Re: Semi-Annual Report Uranerz Energy Corporation Nichols Ranch ISR Project, SUA-1597

Revised pages to the license application are enclosed in accordance with SUA-1597 License Condition 9.4E. An index of change has been included to guide insertion into the license application.

**Nichols Ranch ISR Project
License Number SUA-1597
Docket No.40-9067**

Semi-Annual Report

NICHOLS RANCH ISR PROJECT
FIGURE 3-9A
HEADER HOUSE DETAILS
(TYPICAL)

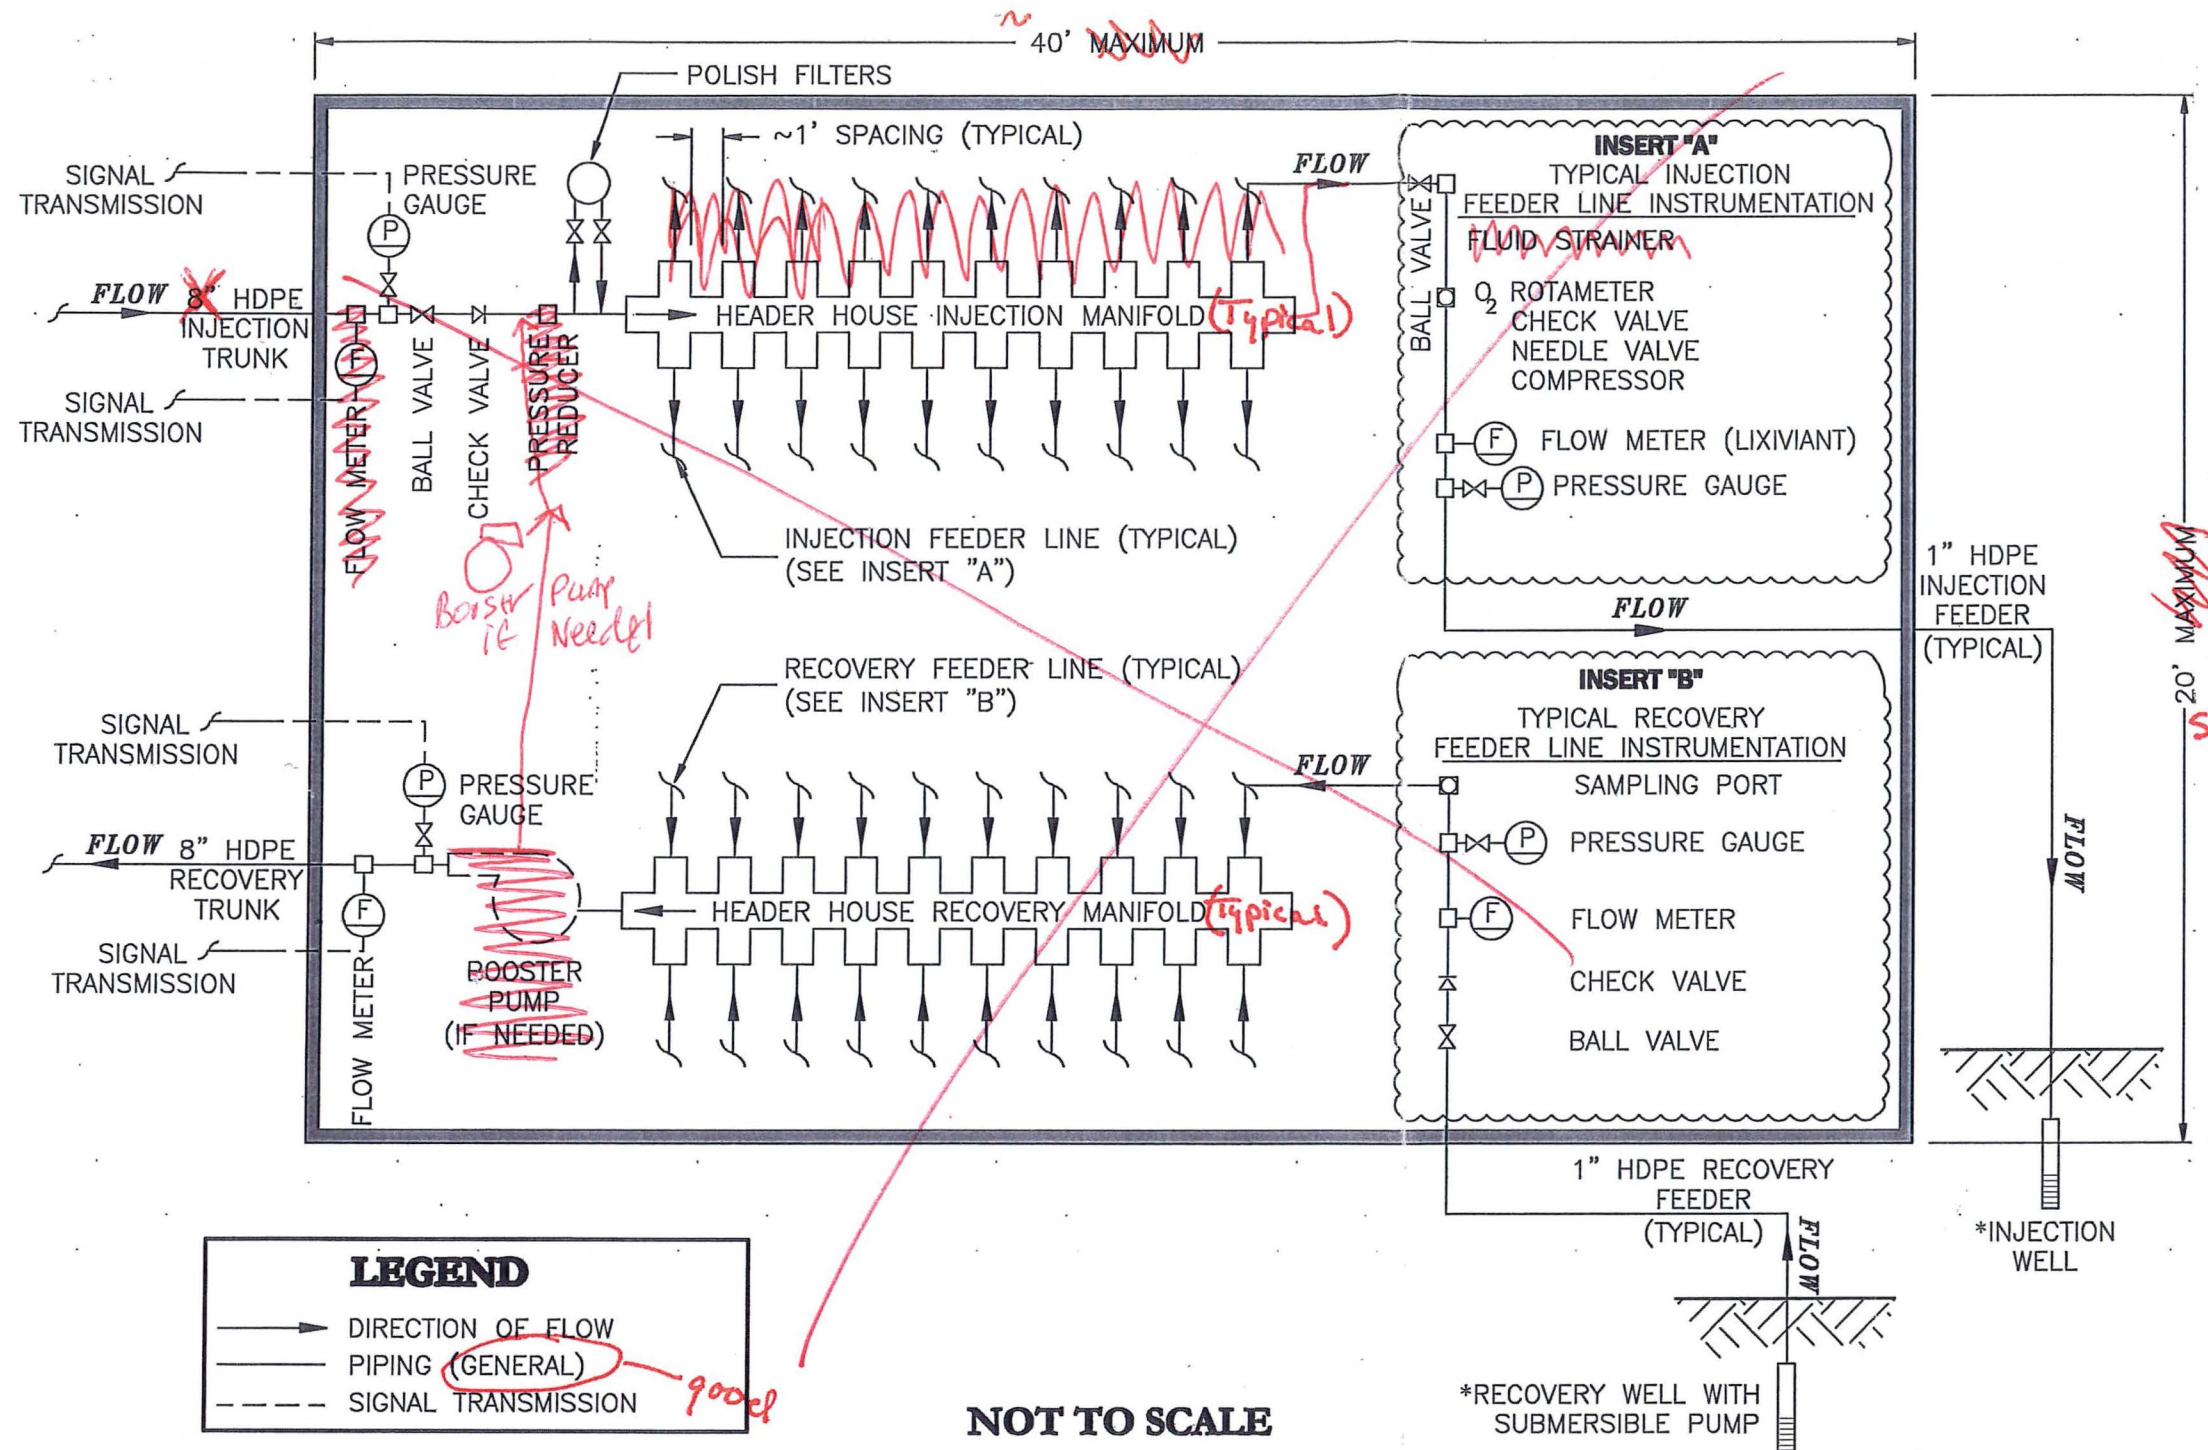
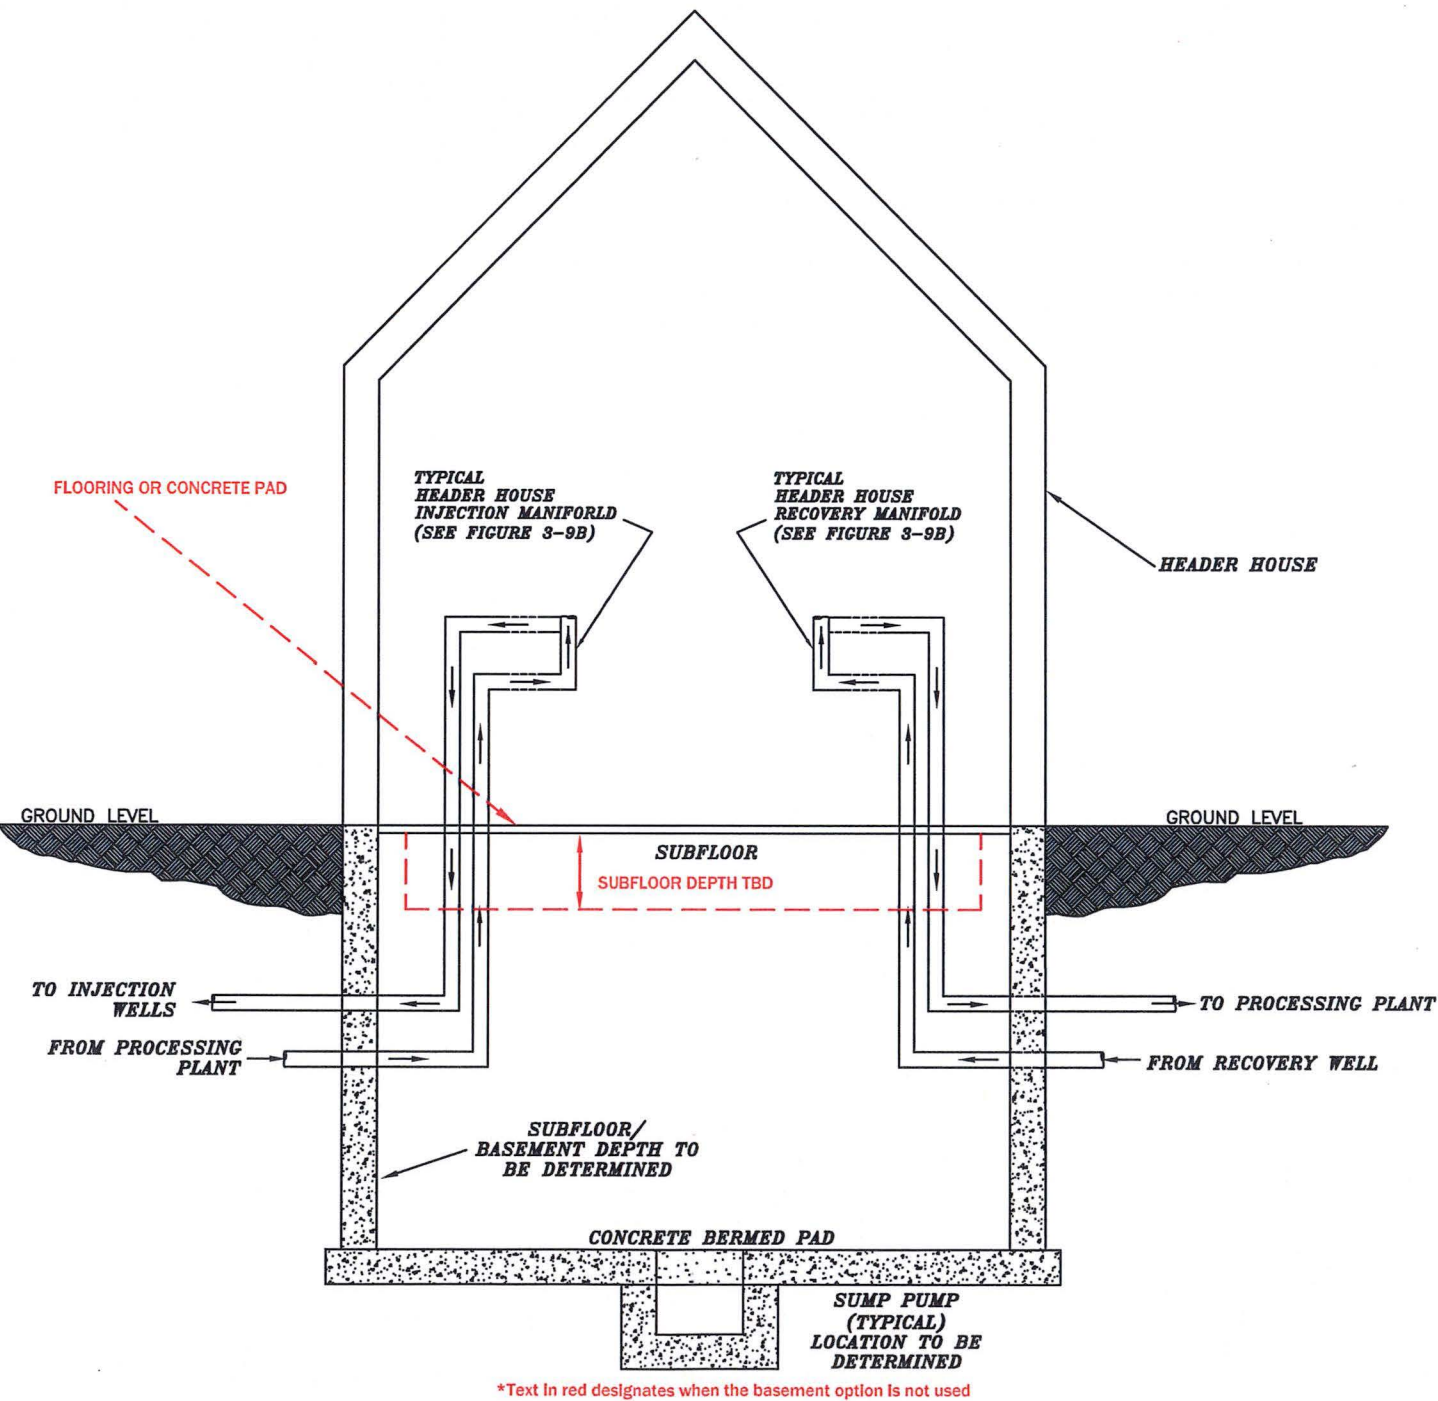
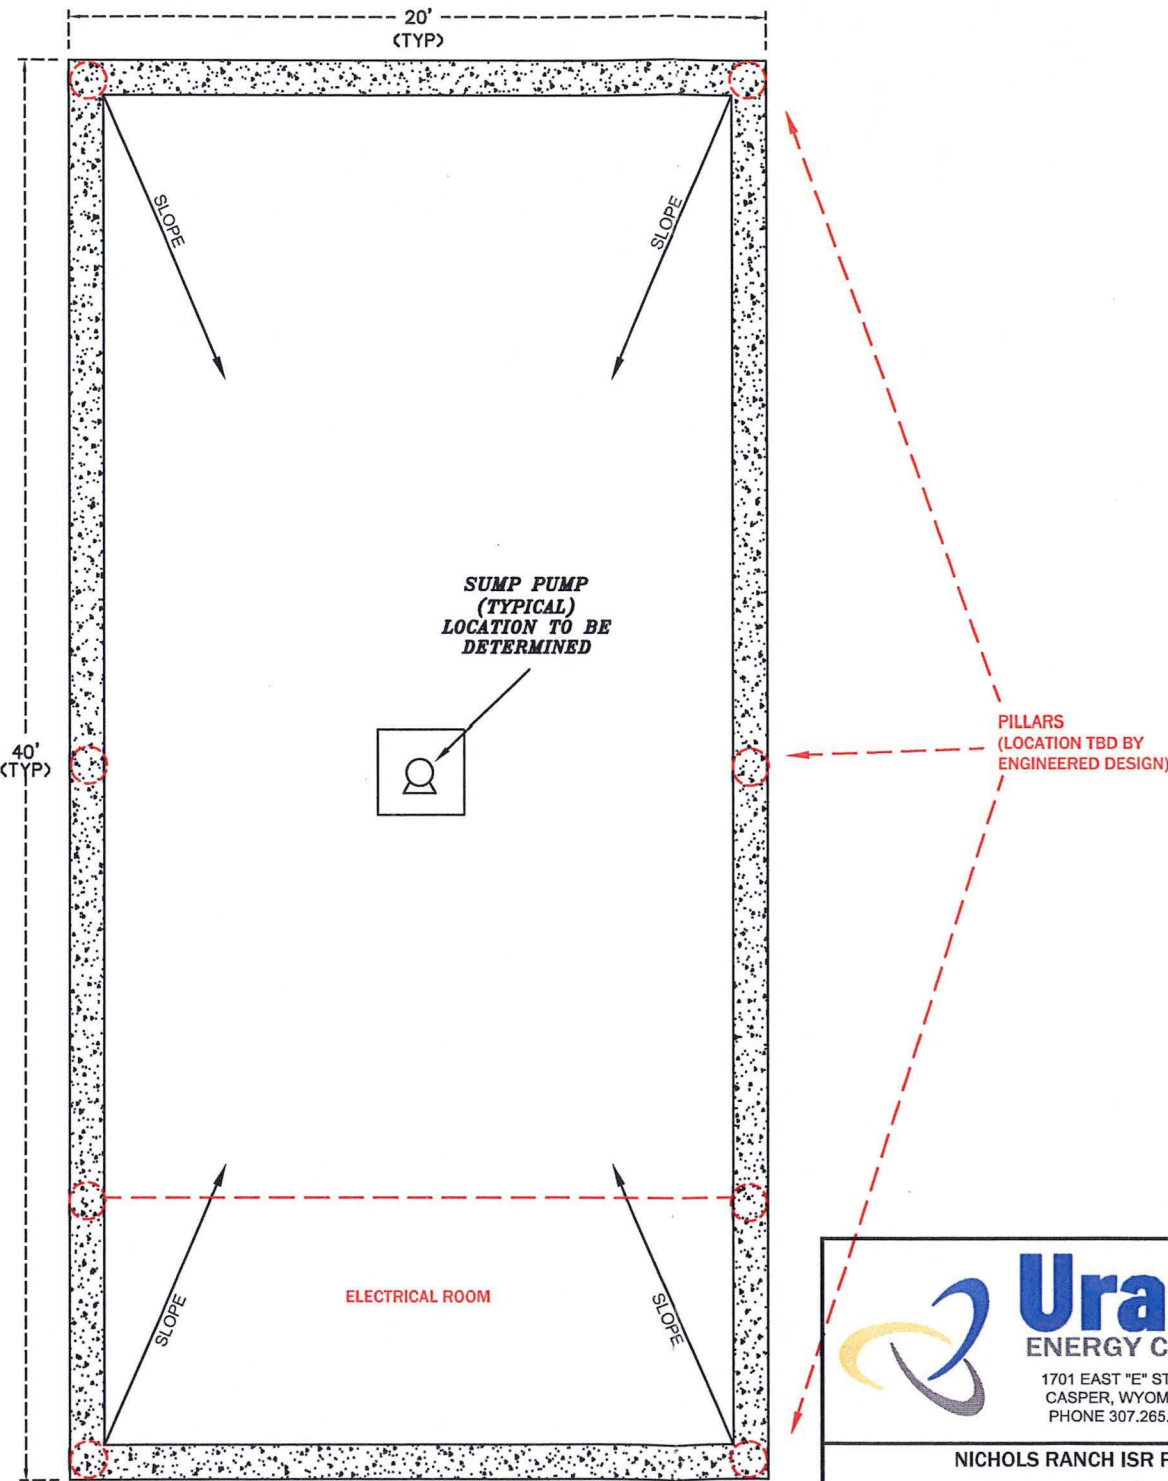
Volume Number	Page, Map or other Permit Entry to be REMOVED	Page, Map or other Permit Entry to be ADDED	Description of Change
Volume I	Pages TR-179 through TR-180a	Pages TR-179 through TR-180a	Changes to description of header house design
Volume I	Table of Contents page TR-ii	Table of Contents page TR-ii	Revised and updated to remove Figure 3-9C
Volume I	Figures 3-9A and 3-9B	Figures 3-9A and 3-9B	Figures were revised to reflect changes to text descriptions on pg TR-170 through TR-180a
Volume I	Figure 3-13	Figure 3-13	Figure updated
Volume I	Figure 5-1	Figure 5-1	Figure updated with new titles and positions per text changes on pages TR-201 through TR-204
Volume I	Pages TR-201 through TR-204	Pages TR-201 through TR-204	Pages revised to include new titles and positions post merger with Energy Fuels
Volume I	Pages TR-309, TR-310	Pages TR-309, TR-310	Pages revised to account for yellowcake slurry shipment

The header houses will be metal buildings. The dimensions for the header houses will be approximately 40 feet by 20 feet, but may be more or less. There are two possible designs for the buildings and foundations. The terrain and logistics in the wellfield will determine which engineered foundation (e.g. pad, pillar, or basement) the header house will be built on. The foundations will be constructed of durable materials that meet engineering requirements or other suitable materials with sealed penetrations (as needed) to provide containment. Depending on the terrain and logistics in the wellfield, one of the two designs will be used. Design A will have the metal building set on top of a foundation built of materials such as concrete or steel. The foundation will have grating which will allow access to the sub floor containing valves and hose runs. The maximum dimensions for the header houses will be up to 40 feet by 20 feet with a six

~~inch concrete pad floor.~~ The floor will slope to a sump with an automatic level control pump. The sump will pipe to the recovery system~~line~~ and will include check valves. ~~Design B will have the metal building set on a pad. The inside of the building will be designed so that the main connection valves and hose runs are behind one of two walls that run~~

~~the length of the header house. The walls will be three to four feet from the building edges, and thus allow for maintenance and operators to conduct their inspections and work on the ground level, and not in the sub floor area. In header houses with basements the basement will contain the hose runs and injection and recovery lines. The header house may be designed to contain the electrical equipment in the same room with the piping or the electrical room may be attached to the main header house building and placed on concrete pillars that are buried underground for structural support.~~

The header houses will be metal buildings. The dimensions for the header houses will be approximately 40 feet by 20 feet, but may be more or less. The terrain and logistics in the wellfield will determine which engineered foundation (e.g. pad, pillar, or basement) the header house will be built on. The foundations will be constructed of durable materials that meet engineering requirements or other suitable materials with sealed penetrations (as needed) to provide containment. The foundation will have grating which will allow access to the sub floor containing valves and hose runs. The floor will curb and/or slope to a sump with an automatic level control pump. The sump will pipe to the recovery system and will include check valves. In header houses with basements the basement will contain the hose runs and injection and recovery lines. The header house may be designed to contain the electrical equipment in the same room with the piping or the electrical room may be attached to the main header house building and placed on concrete pillars that are buried underground for structural support.
